Product Change Notification

Change Notification #: 113737 - 00

Change Title: Intel® 8 Series Chipsets
PCN 113737-00, Transport Media,
Alternate source for Carrier tape and
Cover tape

Transport Media

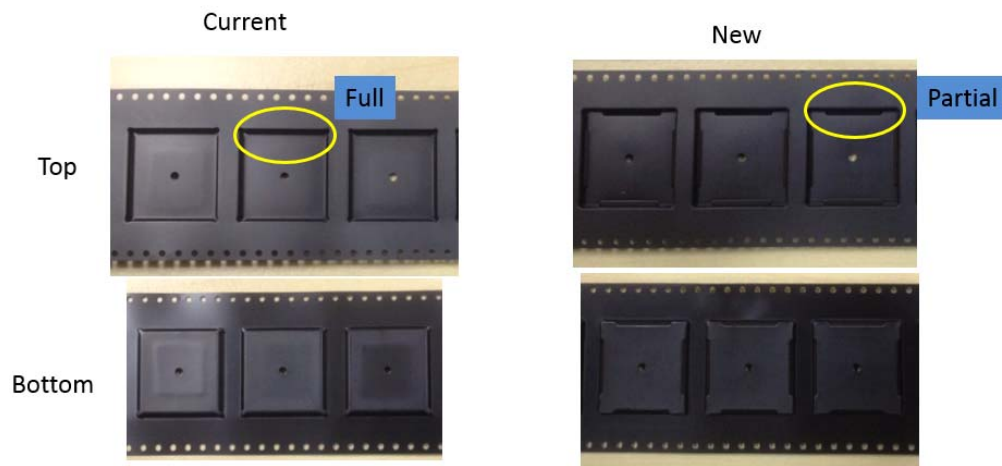
Key Characteristics of the Change:

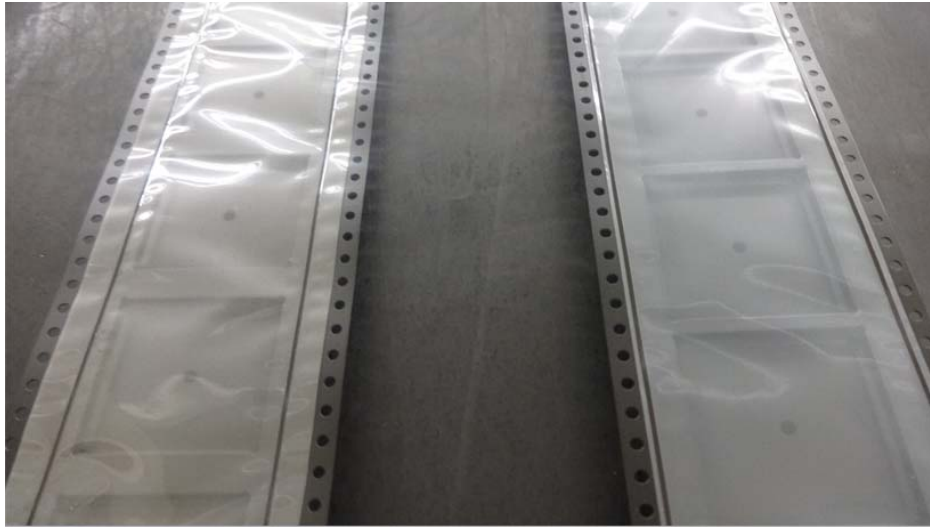
Carrier tape changes: there has been no change in form fit, function or quality of the carrier tape, only the slight change in appearance as indicated below. The ledge on the current pocket provides full contact with the units. The ledge on the new carrier tape pocket provides partial contact with the units, but does not impact loading or removing the units. See carrier tape images below:
